Access Compliance Report

Public Rights-of-Way

Intersection ID: 51704	Main Street: IKEA_BV	Cross Street: BROOKSIDE_LN	Location: NW
ADA ID: 9F0BECDD2CED	Ramp Type: Perp	Initial Pass/Fail: Pass	Overall Compliance: No
		Severity Score: 7.75

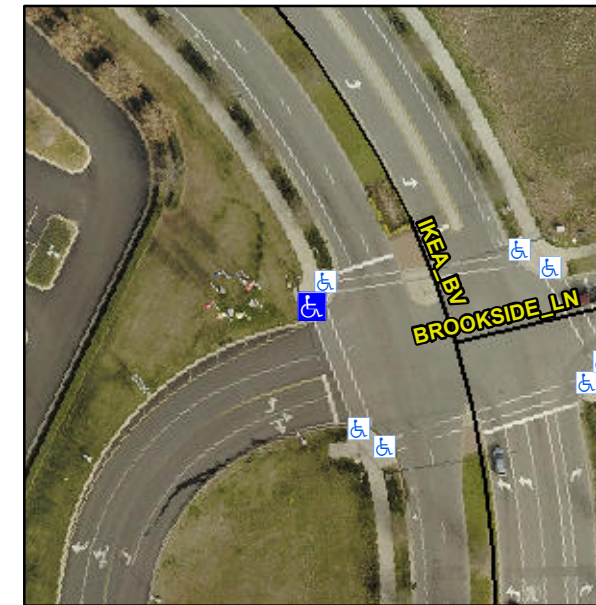
**Not Found, R304.5.3, R304.2.2-Perp,
R304.3.2-Para, R302.7.2**

Compliance	Description	Data	Compliance	Description	Data
N/A	Ramp Length (in)	98.0	Yes	Ramp Slope (%)	7.9
Yes	Ramp Width (in)	48.0	No	Ramp XSlope (%)	2.5
N/A	Flare Type LT	Sloped	N/A	Flare Type RT	N/A
N/A	Flare Slope LT (%)	5.0	Yes	Flare Slope RT (%)	9.9
N/A	Flare Traversable LT?	No	N/A	Flare Traversable RT?	Yes
Yes	Landing Length (in)	94.0	Yes	DWS Provided?	Yes
Yes	Landing Width (in)	48.0	Yes	DWS Contrast?	Yes
No	Landing Slope (%)	2.7	Yes	DWS Length (in)	24.5
Yes	Landing X Slope (%)	1.3	Yes	DWS Full Width?	Yes
N/A	Landing Curb? (Y/N)	No	Yes	DWS Offset (in)	1.5
N/A	Shared Landing?	No			
Yes	Gutter Ponding?	No	Yes	Gutter Slope (%)	0.2
No	Gutter Lip Ht (in)	0.5	No	Gutter X Slope (%)	3.2
N/A	Painted X Walk1?	Yes	N/A	Painted X Walk2?	N/A
	X Walk 1 Direction	To S		X Walk 2 Direction	N/A
N/A	X Walk 1 Width (in)	94.0	N/A	X Walk 2 Width (in)	N/A
	X Walk 1 Slope (%)	1.1		X Walk 2 Slope (%)	N/A
	X Walk 1 X Slope (%)	2.3		X Walk 2 X Slope (%)	N/A

**Remove & Replace Entire Ramp.
Remove & Replace Gutter.**
